## Product change note

**Topic** **Firmware and hardware update for EVK-M8L, EVK-M8U, C93-M8E**  
**Author** **Martin Wallebohr**  
**Date** **6 August 2020**

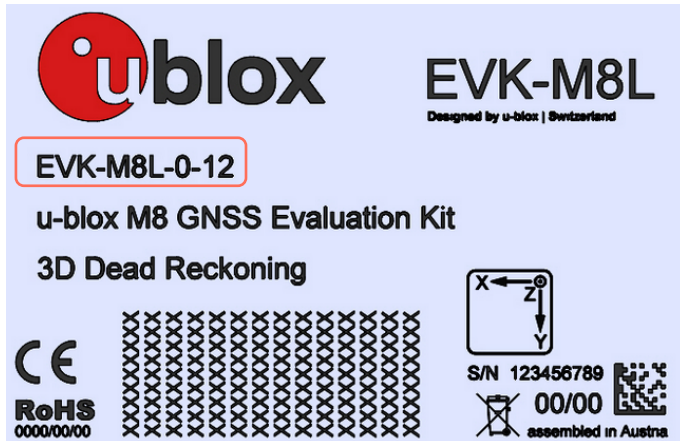
Updated products can be identified by a type number on the label which is marked in red on the figure below. Please note that an updated C93-M8E cannot be identified by label but only by reading out firmware version via UBX-MON-VER [6].
